**DEVIATION REQUEST** (Attach diagrams, figures, and other documentation to clarify request)

A deviation from the standards of or in Section **ECM section 2.3.2 Design Standards** of the Engineering Criteria Manual (ECM) is requested for the Poco Rd and Aspen Valley Intersection K value.

HOMESTEAD NORTH AT STERLING RANCH FILING NO. 3  
 ROADWAY PLAN AND PROFILE

## ASPEN VALLEY ROAD PROFILE (3) STA 15+00.00 TO 18+29.41

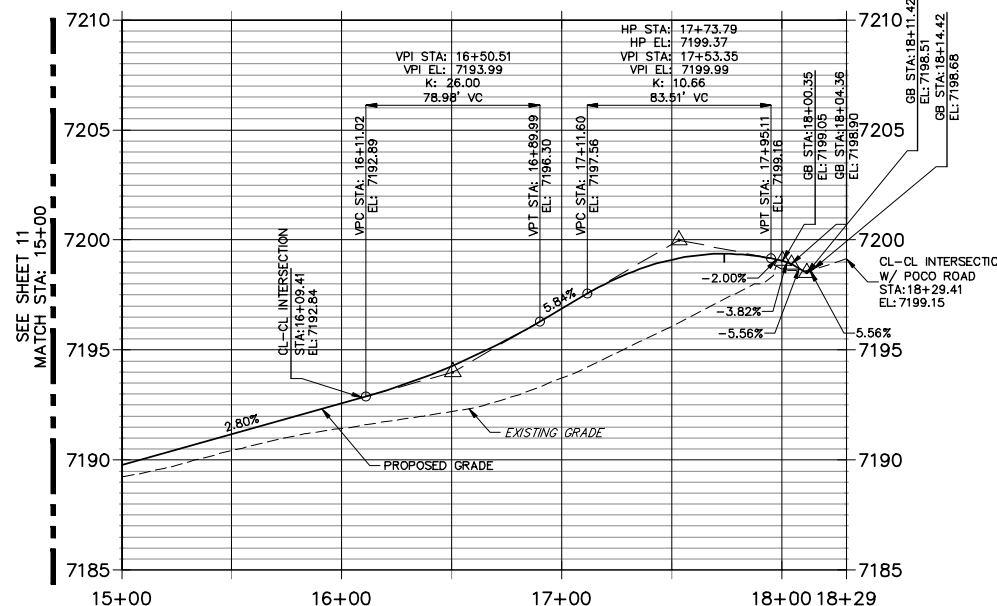
Per ECM Section 2.3.4, Table 2.12, a design speed of 25 MPH would require a K value of 12 on the Aspen Valley crest vertical curve approach to Poco Road.

Per the roadway design for Aspen Valley, the K value of the crest vertical curve is 10.66.

Aspen Valley Road is a urban local road providing Poco Road access to the residential lots within Homestead North at Sterling Ranch Filing No. 3. The natural topography of the area slopes south east which requires Aspen Valley Rd. to rise substantially to meet Poco Road existing grade. Poco Road is a rural road with roadside ditches and its drainage design is to keep the ROW stormwater flows draining east to Sand Creek. To maintain this drainage concept, a crest vertical curve was placed near the intersection. The proximity of the crest vertical curve to the intersection necessitated shorter vertical curve with a K value of 10.66 versus the ECM standard of 12.

The natural topography of the area slopes south east which requires Aspen Valley Rd. to rise substantially to meet Poco Road existing grade. Poco Road is a rural road with roadside ditches and its drainage design is to keep the ROW stormwater flows draining east to Sand Creek.

There is a 5.84% rising slope in Aspen Valley followed by a 2% downslope to Poco. The vertical curve was placed as close to the intersection as practical, to lessen the fill requirements.
